To: T10 Technical Committee
From: Rob Elliott, HP (elliott@hp.com)
Date: 9 December 2004
Subject: 04-370r2 SAS-1.1 Merge IT and IR with XT and XR

Overview

Suggested changes

Figure 1 — External cable CT and CR compliance points

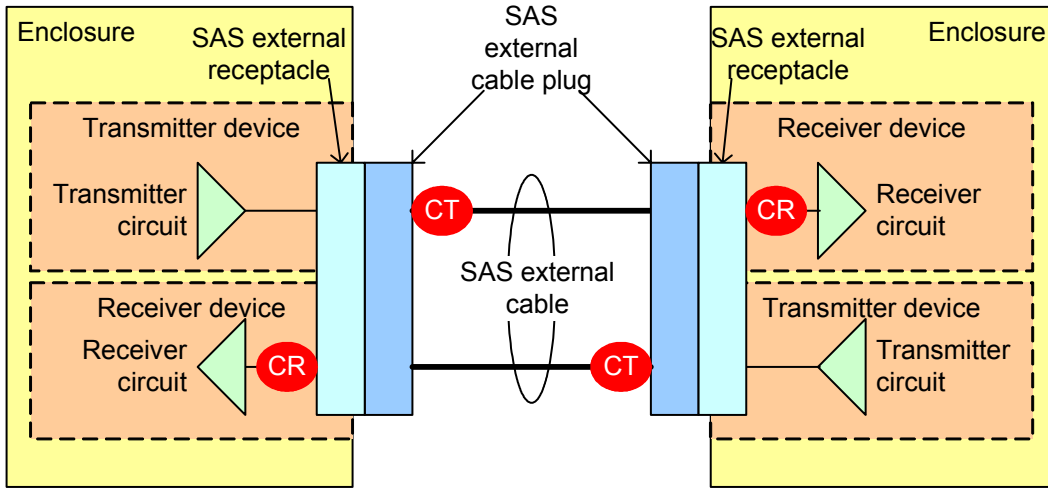
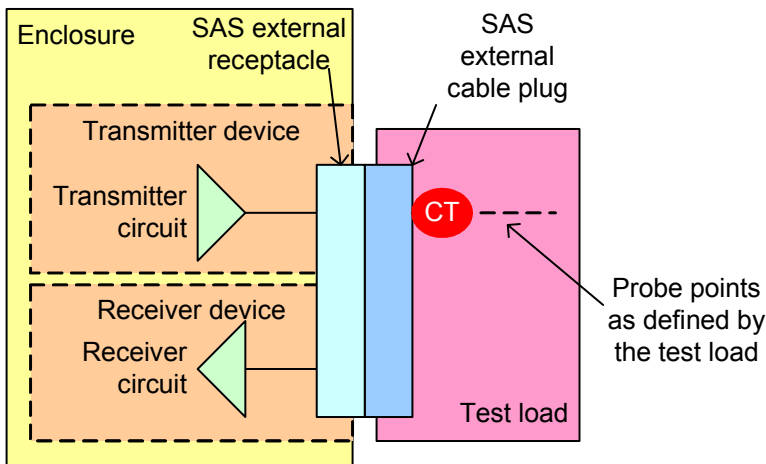
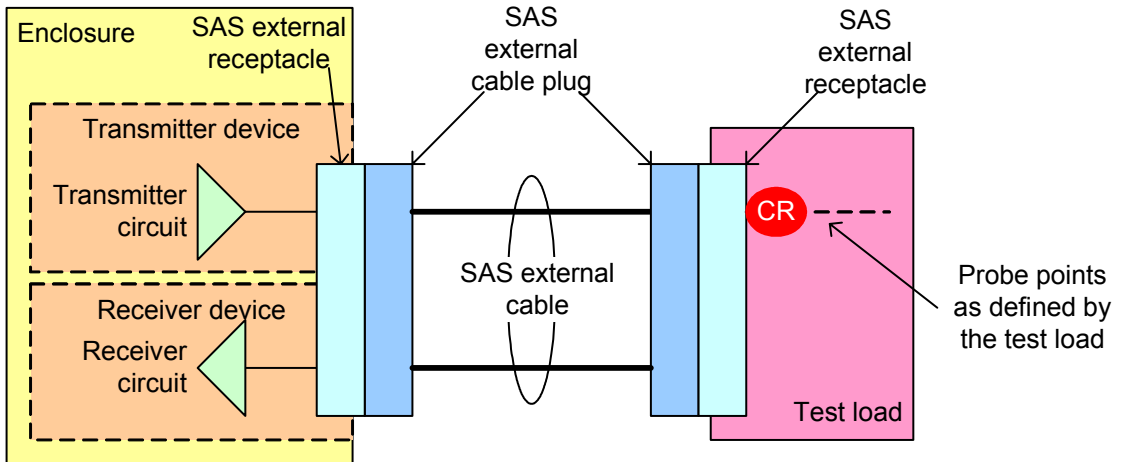
2. There is some confusion over where exactly the compliance points are located. Proposed figures are added showing the location of the compliance points for each type of connector interface and how the test loads are used to test compliance at those points.

Figure 1 shows the locations of the CT and CR compliance points using an external cable, and shows how two of the compliance points are tested using test loads with SAS external connectors (see figure 68 and figure 69 in 5.3.11).

Figure 2 — Backplane IT and IR compliance points

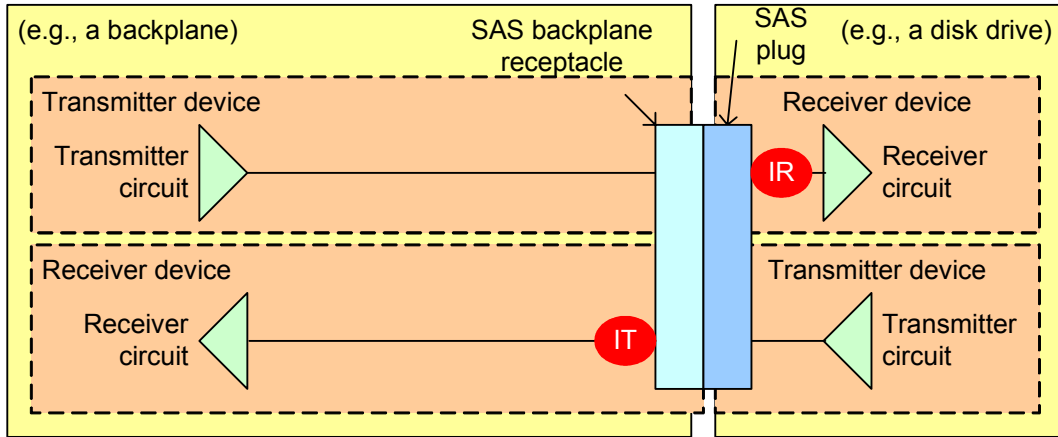
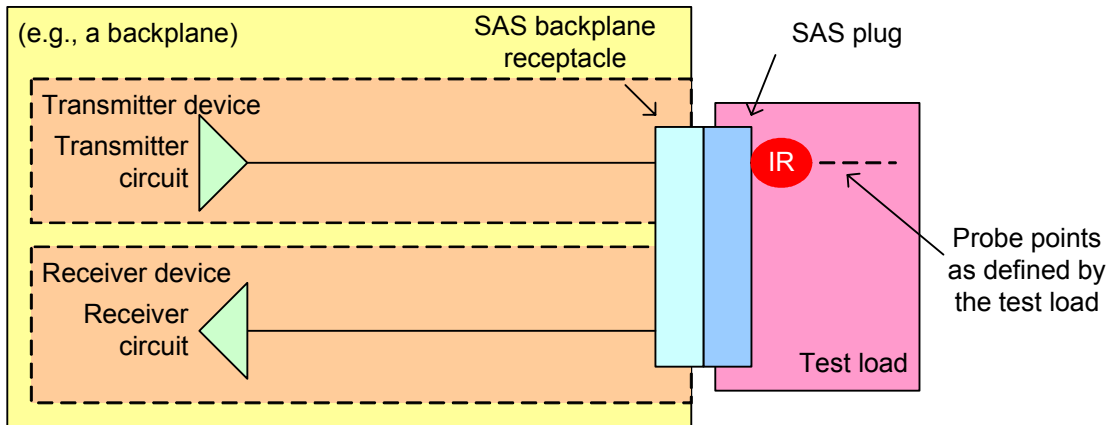
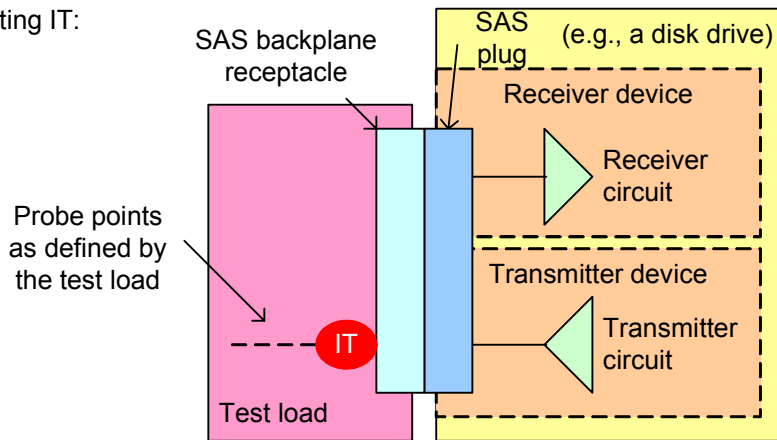
Figure 2 shows the locations of the IT and IR compliance points using a backplane with a SAS backplane receptacle (see 5.2.3.4) that is not attached to a SATA device, and shows how the compliance points are tested using test loads with SAS internal connectors (see figure 68 and figure 69 in 5.3.11).

Figure 3 — Backplane compliance points with SATA device attached

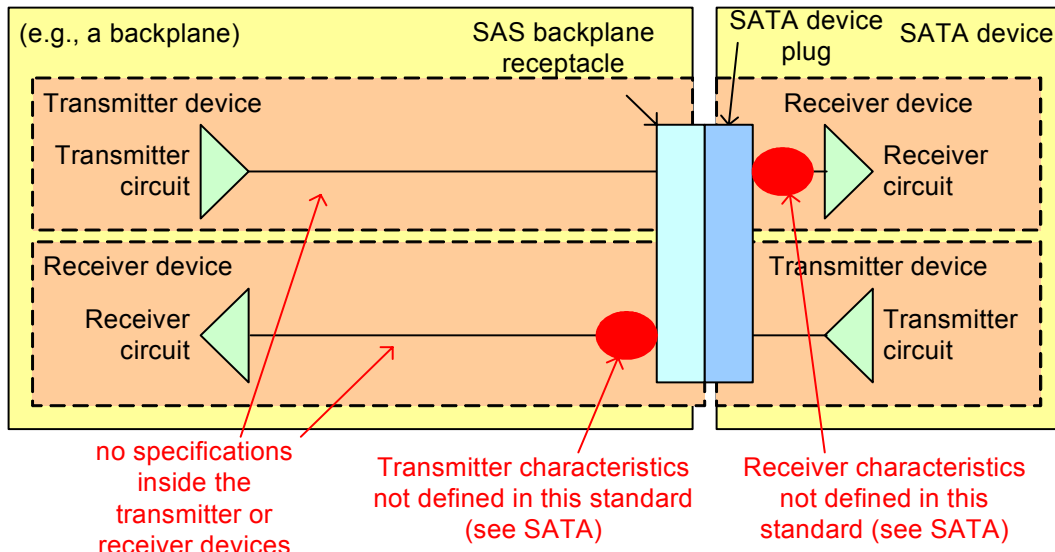
If the backplane supports SATA devices being attached to the SAS backplane receptacle (see 5.2.3.4), there are no IT or IR compliance points. SATA defines the signal characteristics that the SATA device delivers and that the SAS backplane is required to deliver to the SATA device, as shown in figure 3.

Figure 4 — Internal wide cable IT and IR compliance points

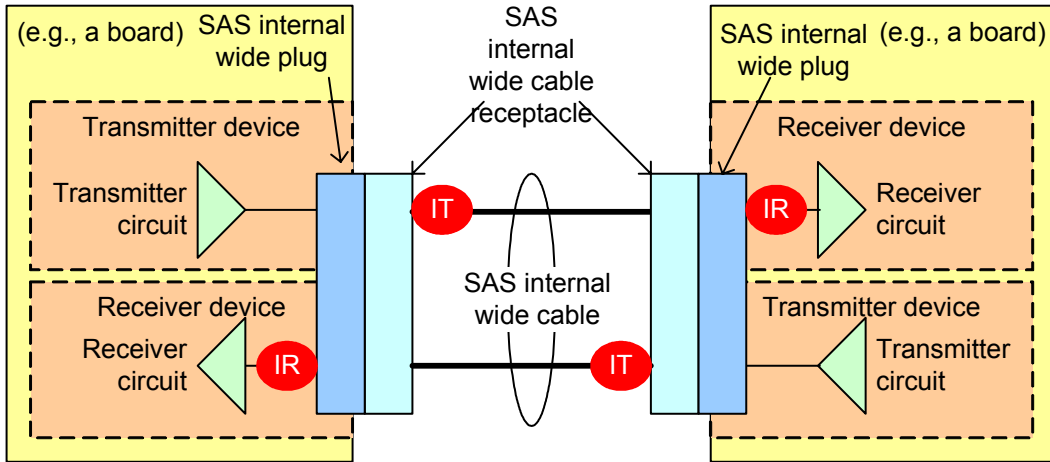
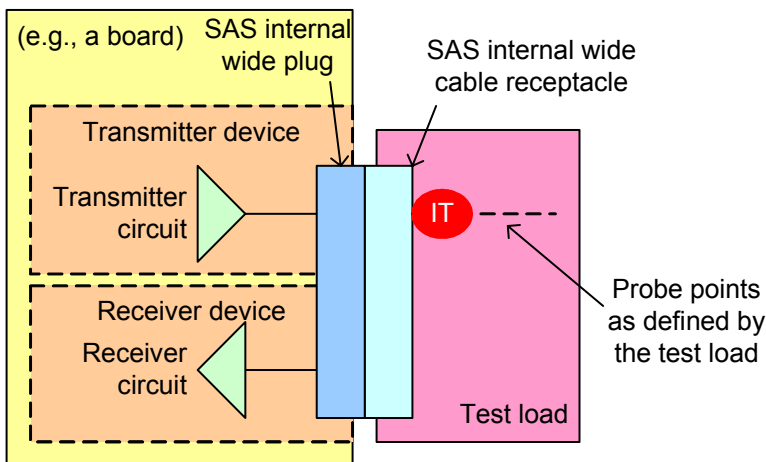
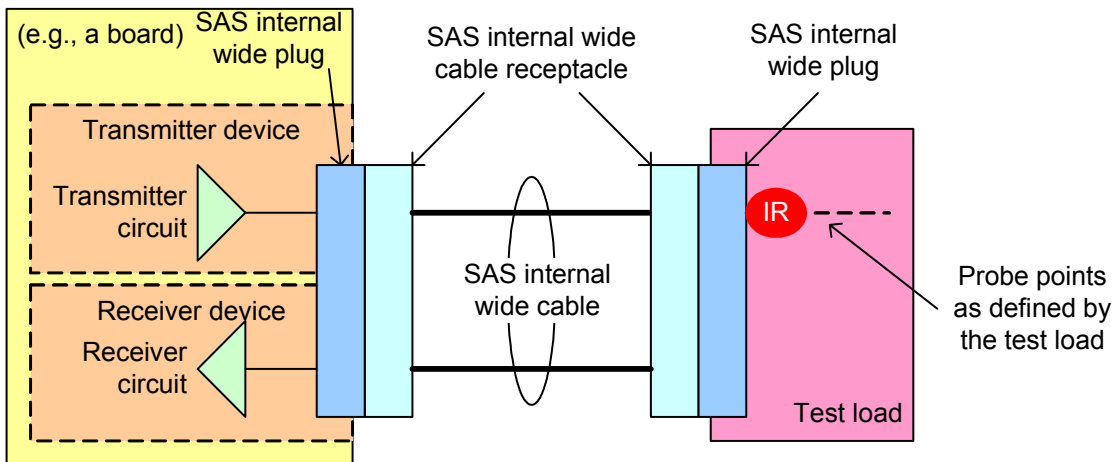
Figure 4 shows the locations of the IT and IR compliance points using an internal wide cable, and shows how two of the compliance points are tested using test loads with SAS internal connectors (see figure 68 and figure 69 in 5.3.11).

Figure 5 — Internal wide cable and backplane IT and IR compliance points

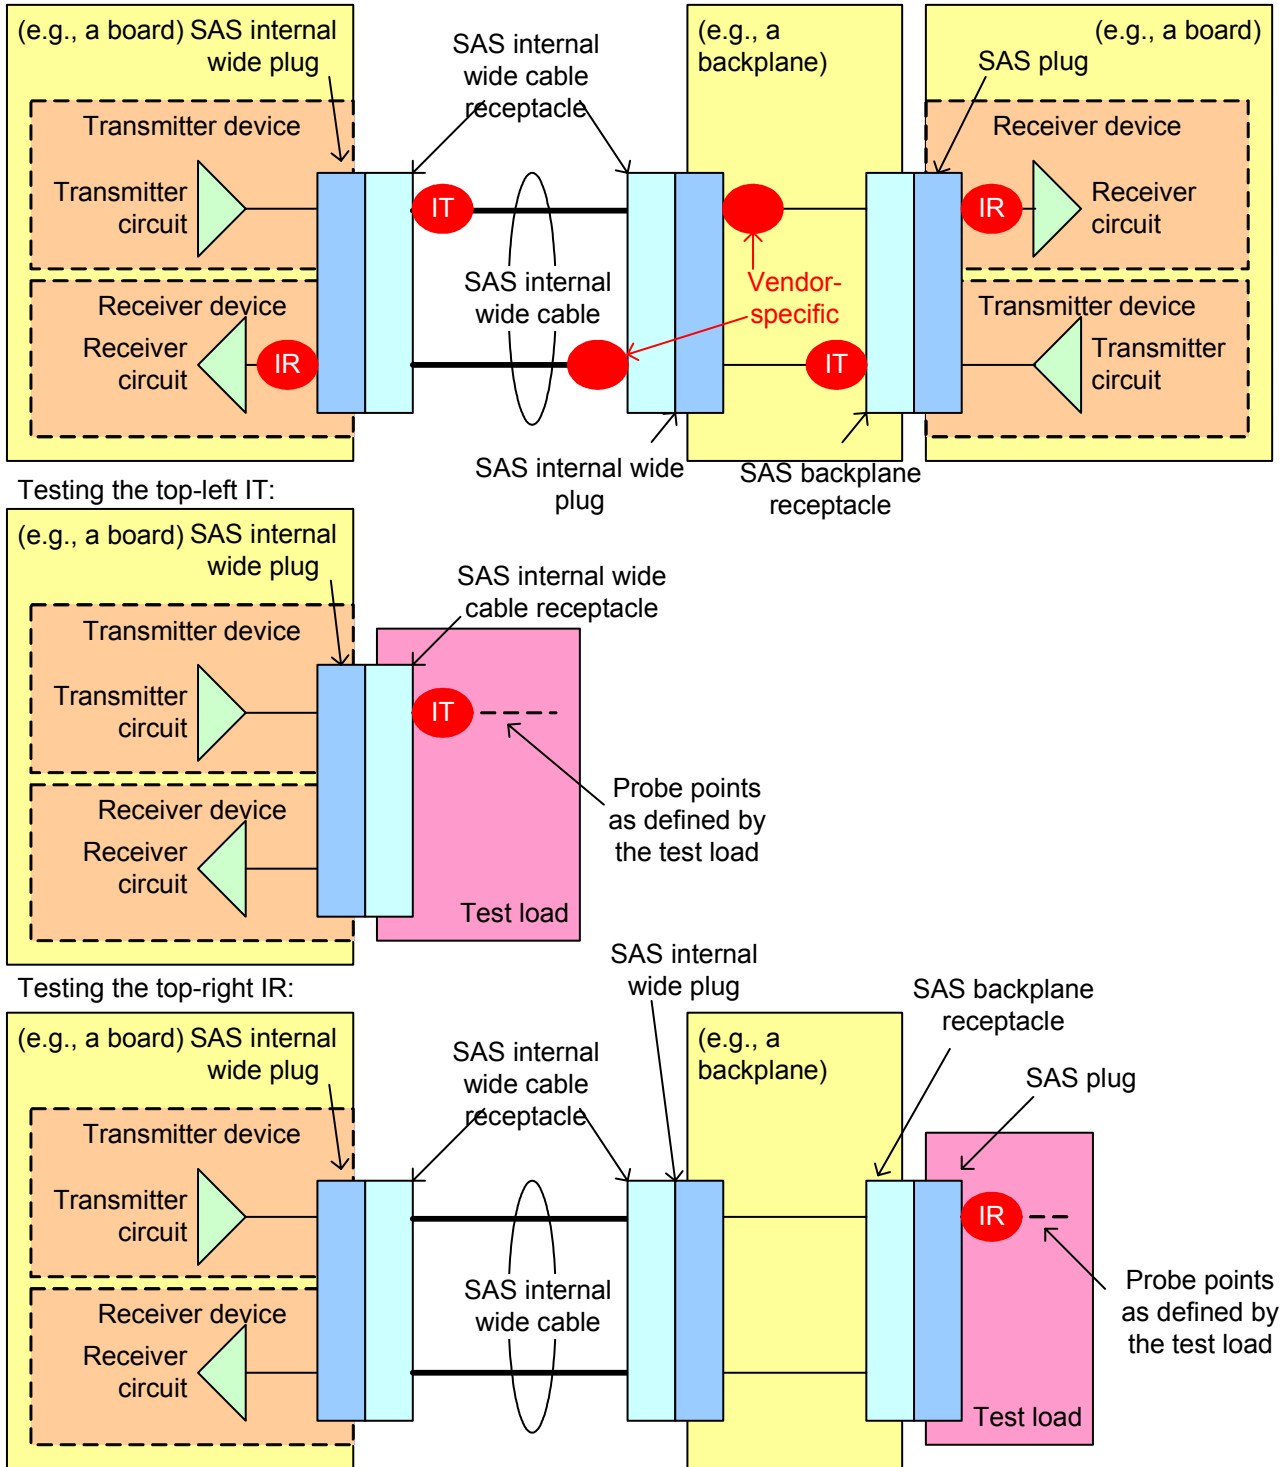
Figure 5 shows the locations of the IT and IR compliance points using an internal wide cable and a backplane, where the backplane is not attached to a SATA device. It also shows how two of the compliance points are tested using test loads with SAS internal connectors (see figure 68 and figure 69 in 5.3.11)

Figure 6 — Internal cable and backplane compliance points with SATA device attached

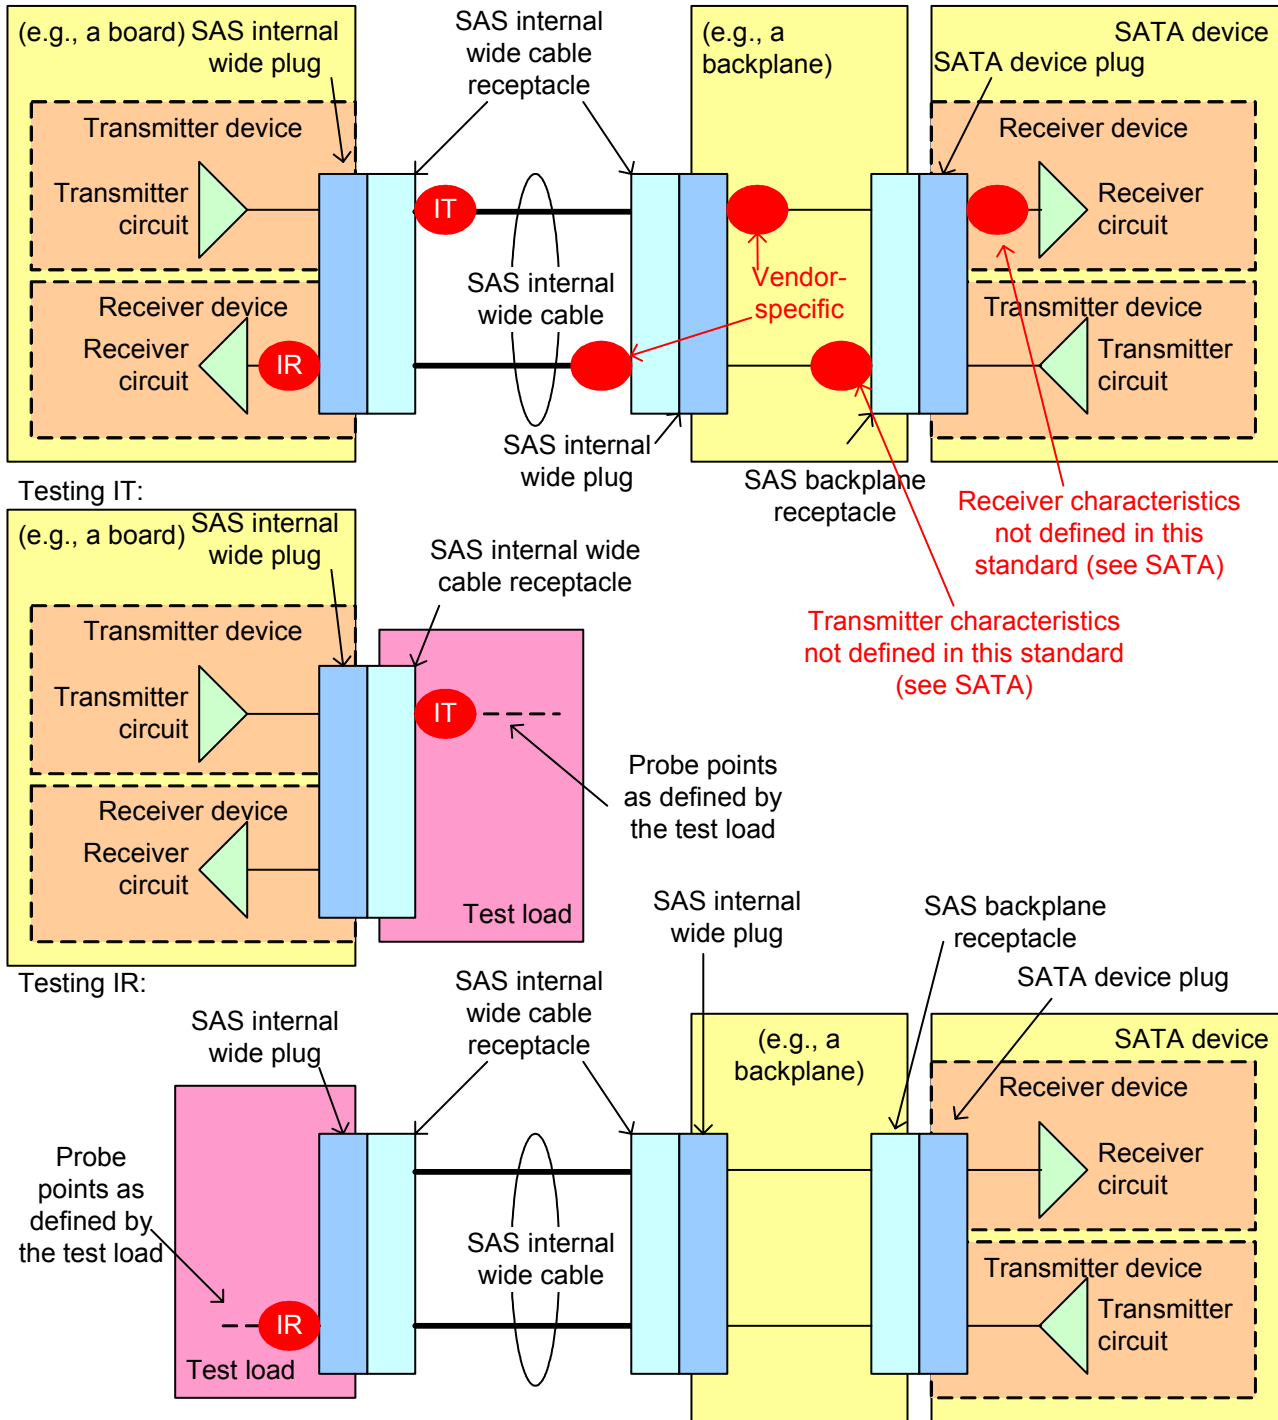
Figure 6 shows the locations of the IT and IR compliance points using an internal wide cable and a backplane, where the backplane supports being attached to a SATA device. There are no IT and IR compliance points at the SAS backplane receptacle connector when a SATA device is attached; SATA defines the signal

characteristics that the SATA device delivers and that the SAS backplane is required to deliver to the SATA device. There are compliance points at the internal wide connector, however.

Figure 7 — Internal cable IT and IR compliance points

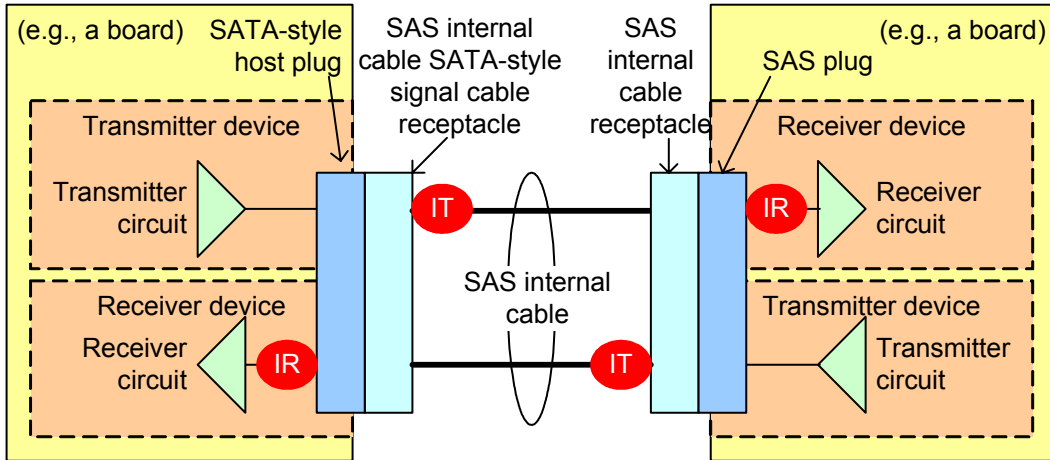
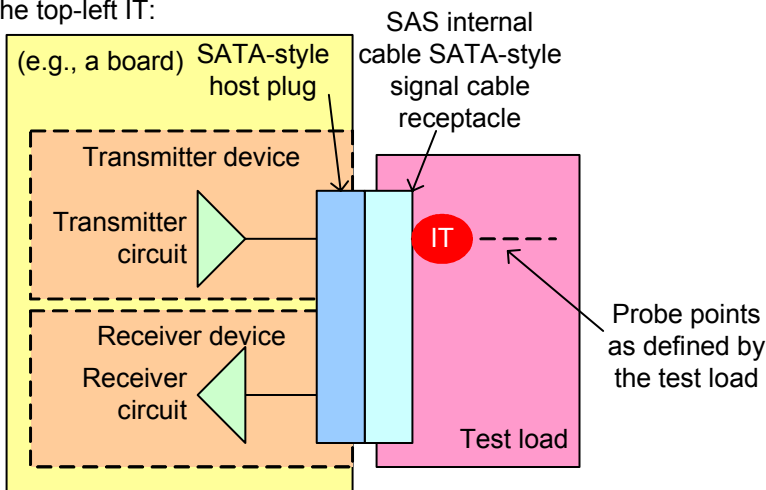
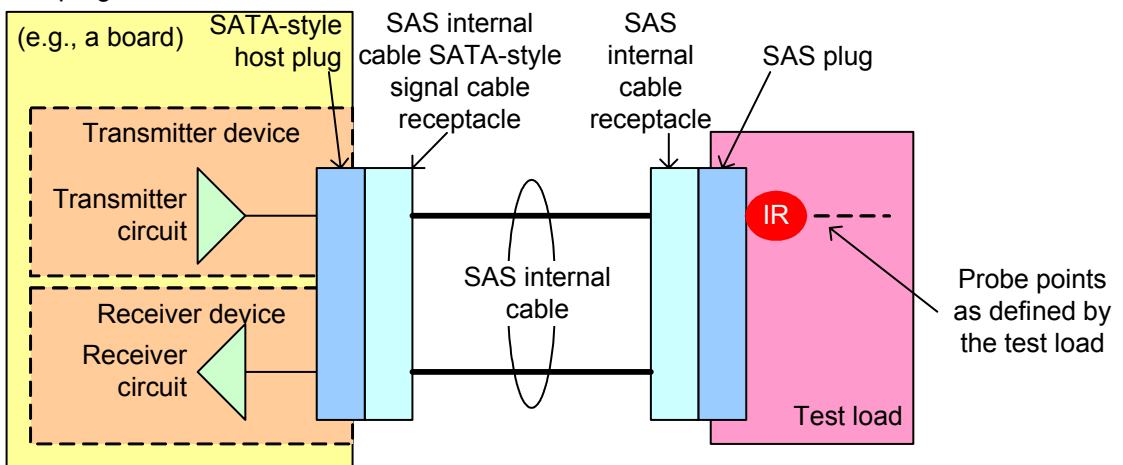
Figure 7 shows the locations of the IT and IR compliance points using an internal cable.

Figure 8 — Transmitter device transient test circuit

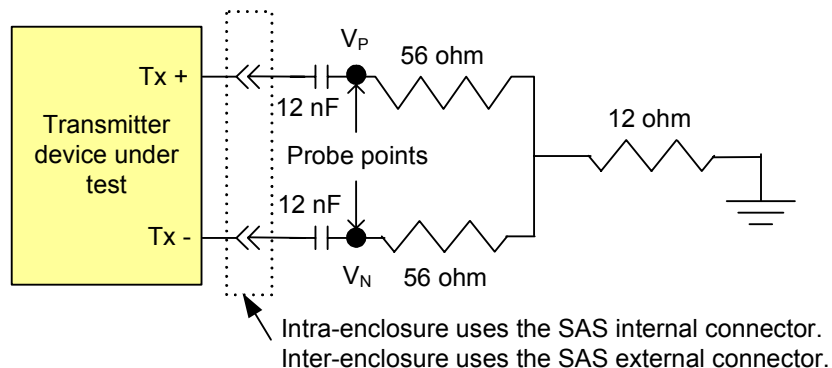
Editor's Note 2: moved these figures after the main table rather than before

Figure 8 shows the transmitter transient test circuit attached to IT or CT to test transmitter device transients.

Figure 9 — Receiver device transient test circuit

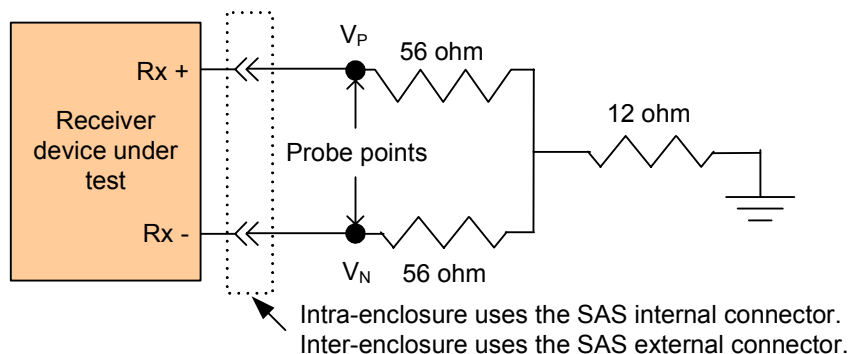
Figure 9 shows the receiver transient test circuit attached to IT or CT used to test receiver device transients.

Figure 11 — ~~Eye mask at IR, CR, and XR~~ Receiver device eye mask

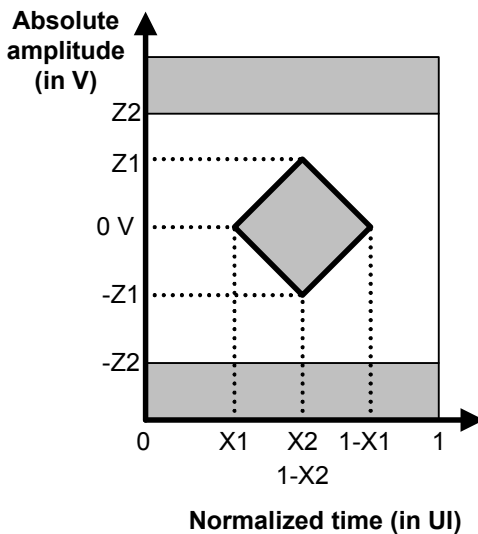
Figure 11 describes the ~~receive~~ eye mask used for testing the signal delivered to the receiver device at IR and CR. The signal shall be measured using a jitter timing reference (e.g., a golden PLL) that approximates a single pole (i.e., 20 dB per decade) low-pass filter with corner frequency of $((\text{bit rate}) / 1\ 667)$. This requirement accounts for the low frequency tracking properties and response time of the CDRs in receiver devices.
